DESIGN #	DRAWN BY CP	DART AEROSPACE LTD HAWKESBURY, ONTARIO, CANADA	
CHECKED #	APPROVED #	DRAWING NO. DSI 9257	REV. A SHEET 1 OF 1
DATE 03.03.20		TITLE RACK & RESERVOIR ASSEMBLY	SCALE NTS
A	03.03.20	NEW ISSUE

DART SERVICE INSTRUCTION

TO AMEND BHA-DRA-358-11 SHEET 2, REV. C

AND IIN-D206-590 REV. NI

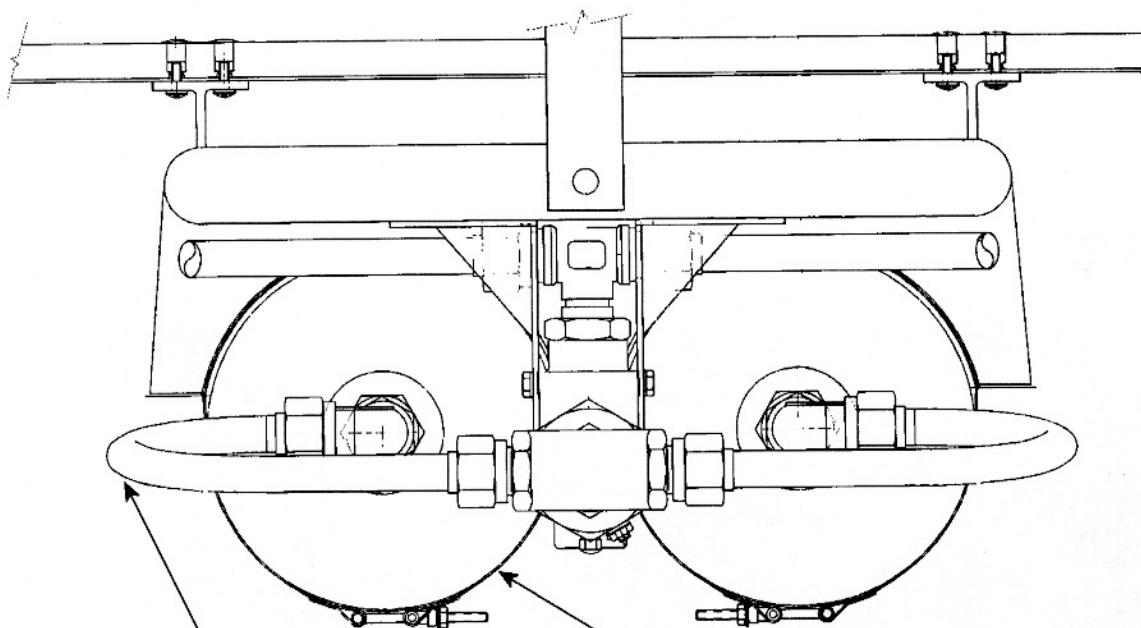
THE FOLLOWING CHANGES HAVE BEEN MADE TO THE RACK AND RESERVOIR ASSEMBLY
(REF. HELITECH P/N 358-021-001 & DART KIT P/N D206-590-017):

469-035-002 TUBE ASSEMBLY (2)
REPLACES 358-035-011 TUBE ASSEMBLY (2)

MS20426AD3-6 RIVET (12)
MS21920-61 CLAMP (4)
MS27833-6-300 PAD (8)
REPLACES 358-027-001 BOTTLE CLAMP (2)
